DATE ~~R~~ Feb. 5/03**V2500-A5/D5 PROPULSION SYSTEMS SERVICE BULLETIN**

This document transmits Revision 1 to Service Bulletin EV2500-72-0412 and
 Revision 1 to the Supplement

ENGINE – PROVIDE ADDITIONAL OIL DRAIN HOLE IN 2ND STAGE TURBINE AIR SEAL

V2500-ENG-72-0412

location of the stage 2 high pressure turbine air seals
Fig 1

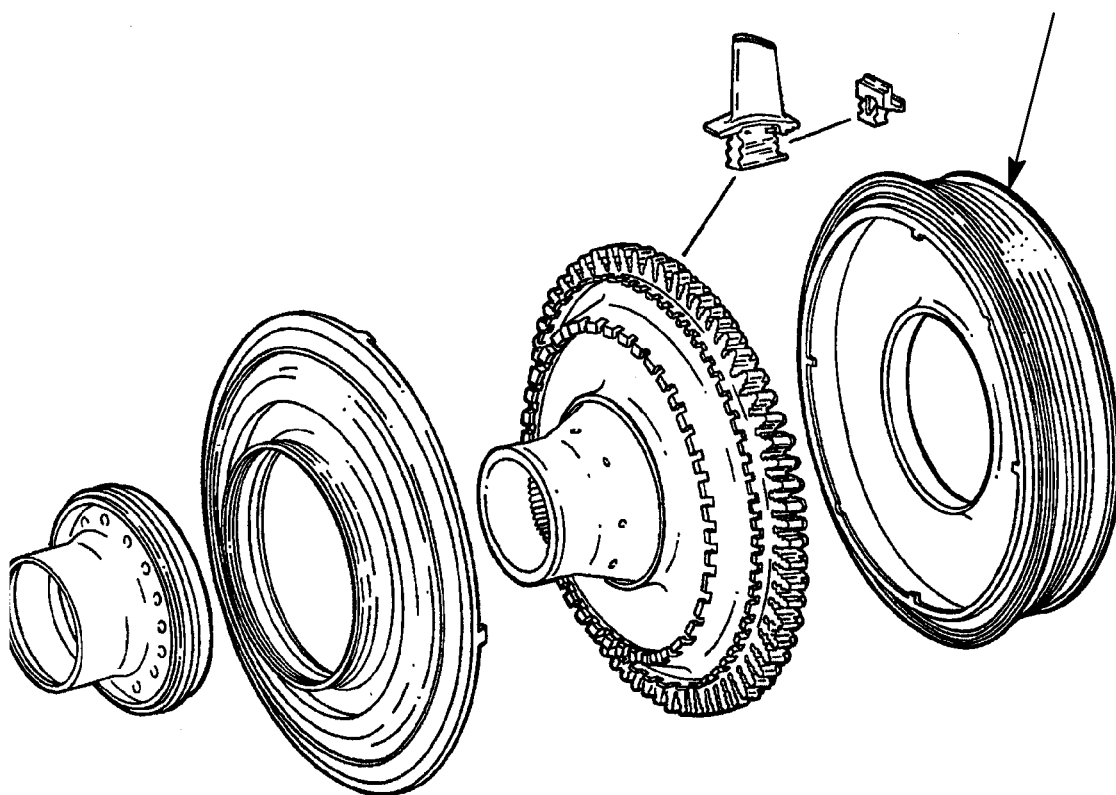
Incorporate an oil drainage feature (hole) in front of the 1-2 seal to allow any accumulated oil to properly drain from this cavity prior to ignition.

Replace the 2nd stage HPT Air Seal with a seal that has the additional drain hole for proper drainage.

- (1) Install the 2A3596 Stage 2 High Pressure Turbine Air Seal when you assemble the High Pressure Turbine Rotor And Stator Assembly by the procedure given in Reference (7) or (8), Engine Manual, Chapter/Section 72-45-00, Assembly. See Figure 1.
- (2) When you assemble the new High Pressure Turbine Rotor and Stator Assembly identify it by the procedure given in Reference (9), Chapter/Section 70-09-00 Marking of Parts.
- (3) Recording Instructions
 - (a) A record of accomplishment is required.

INSTALL THE 2A3596
STAGE 2 HIGH PRESSURE
TURBINE AIR SEAL (1 OFF)

Family tree stage 2 high pressure turbine air seal Ref. Catalog Sequence No.
72-45-00, Fig 01 Item 082
Fig 2

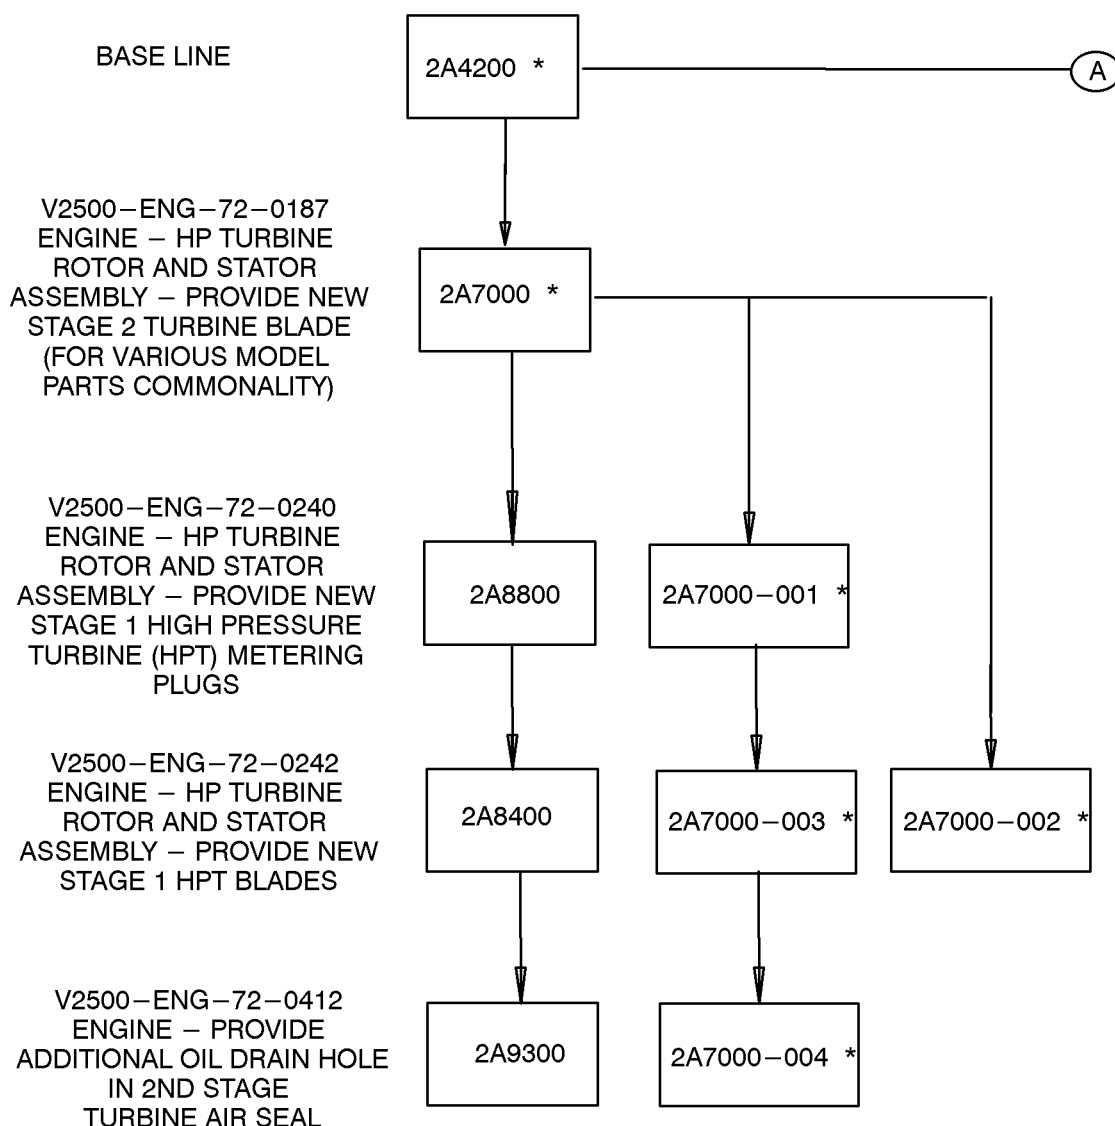
V2500-ENG-72-0412
ENGINE – PROVIDE ADDITIONAL OIL DRAIN
HOLE IN 2ND STAGE TURBINE AIR SEAL

Fig 3 (sheet 1)

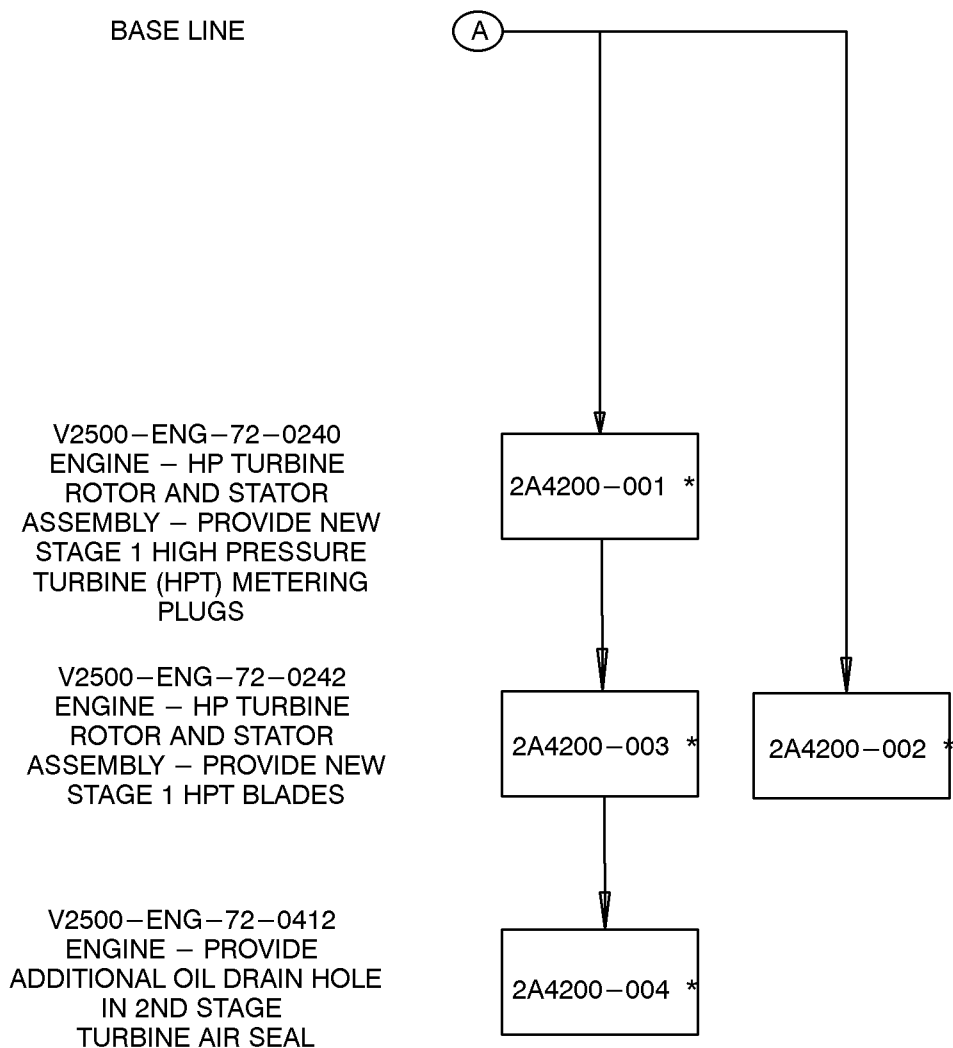
E8431
PWHFamily tree Rotor and stator assembly HPT module V2522-A5, V2524-A5, V2527-A5,
V2527E-A5, V2527M-A5, V2530-A5 and V2533-A5 engines

Fig 4

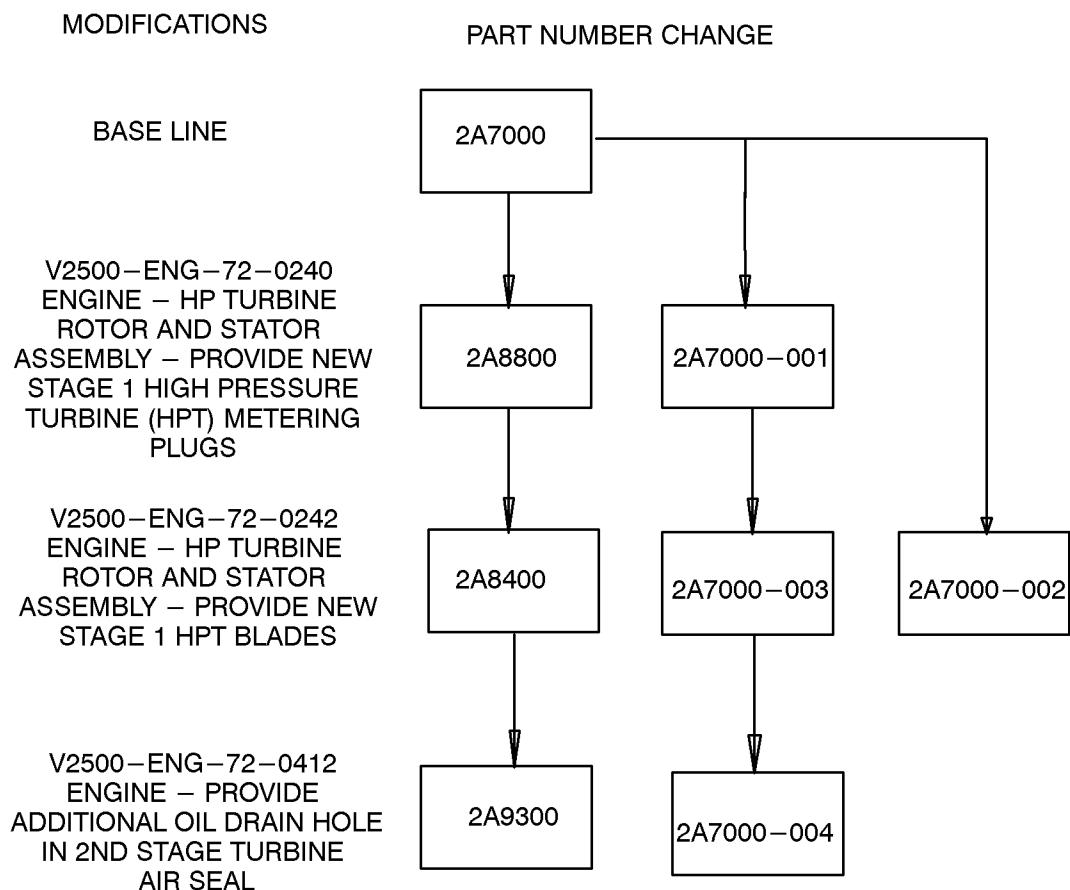
Family tree Rotor and stator assembly HPT module V2525-D5 and V2528-D5 engines Ref
Catalog Seq. No. 72-45-00 Fig 01 Item 001
